REQUEST FOR INFORMATION	DATE: June 16, 2016	NO.: RFI-172
--------------------------------	----------------------------	---------------------

Project Name: 15051-Webster University Interdisciplinary Science Building	Project No.: 15051
---	--------------------

Subject: Storm sewer line conflict with grade beam and drain tile.

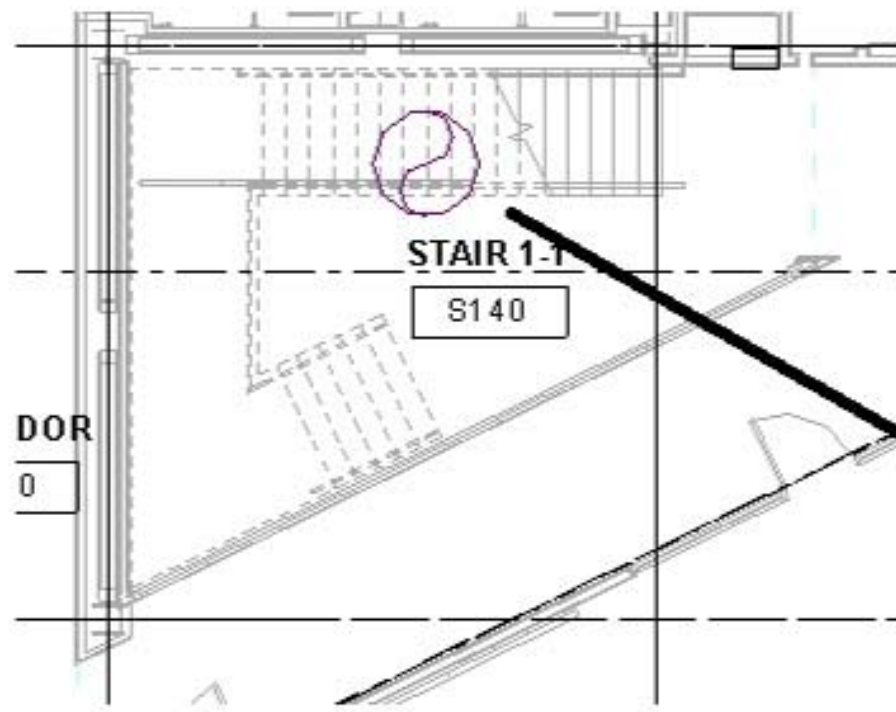
The 12" underground sewer inside of the building footprint conflicts with the bottom of the grade beam near 5 line and 2 locations of drain tile East of 5 line in the run between structure 12 and the exterior of the building. Please advise how to resolve these conflicts – if the grade beam depth can be reduced, or if the drain tile elevations should be modified, or if the 12" line should be adjusted. Also, East/West the alignment of the 12" line is critical because it needs to fit between the Level 0 foundation walls and the Level 1 shoring adjacent to the EAB between column lines 5 & 8 along with the plumbing drain line in this same area. The manhole for structure 22 will be partially underneath Stair #1 per the attached .jpg. Please confirm this location is acceptable.

SEE ATTACHED SKETCH FOR MODIFICATION AT GRID 5 FOR SEWER CONFLICT. THE CONFLICT HEIGHT PER DEVIN GATES IS APPROXIMATELY 3", THEREFORE A BLOCKOUT IN THE GRADE BEAM OF 6"+/- CAN BE PROVIDED. MODIFIED REINF DETAIL IN ATTACHMENT.

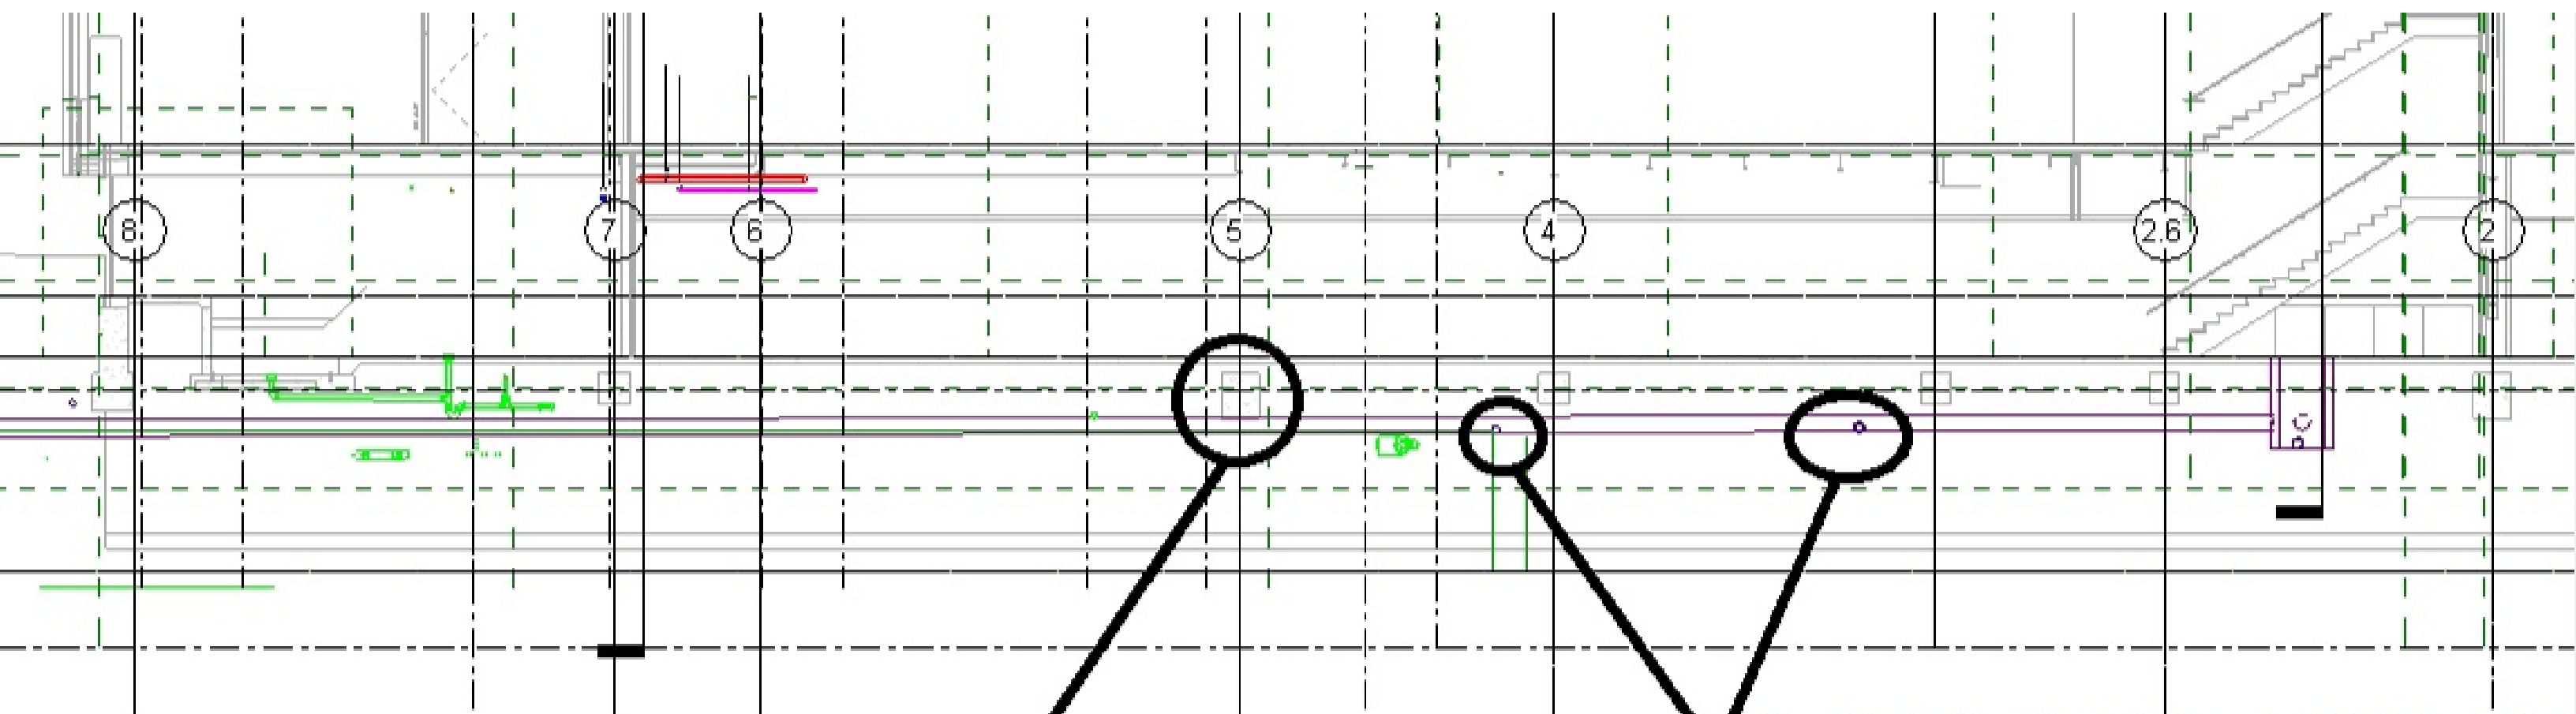
APPROXIMATE
LOCATION OF
MANHOLE IN
AREA B, 48"
DIAMETER.
AIRTIGHT COVER.

CONFLICT WITH
GRADE BEAM

CONFLICT WITH
DRAINTILE
